**Land off Station Road,
Market Bosworth
Ref: 24/01079/OUT
LVIA Review**

Prepared by LUC
March 2025

Land off Station Road, Market Bosworth LVIA Review

Figure 5.2 Applicant's development framework plan highlighted with area of potentially reduced height development parameters (red circle) to ensure visual connection (blue arrow) with north Leicestershire is maintained from Station Road.

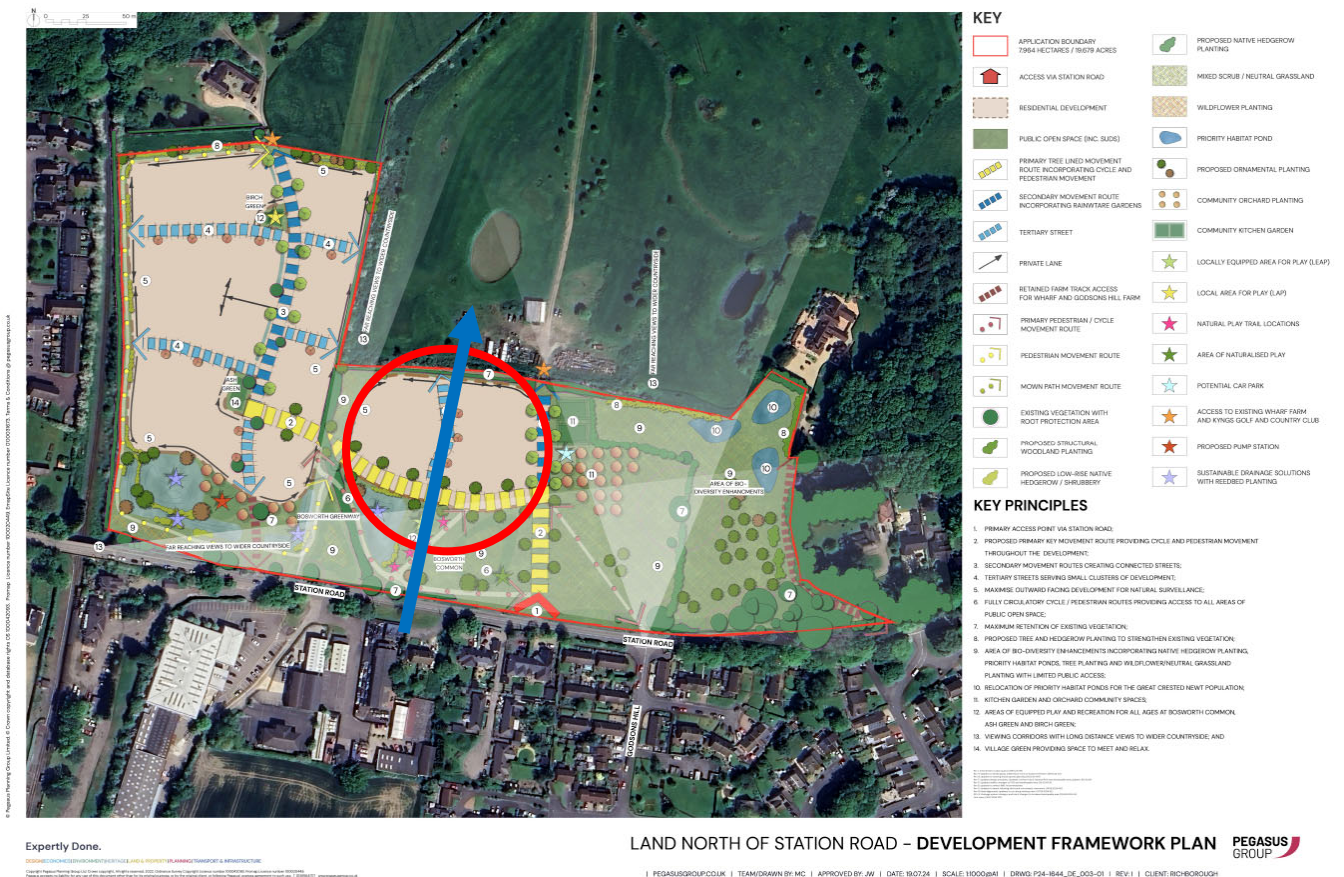
- Lower level (single storey or dormer) properties within development parameters to the east, where land starts to rise would enable the retention of greater visual connection with north Leicestershire (as indicated in Figure 5.2) when viewed by receptors using Station Road.
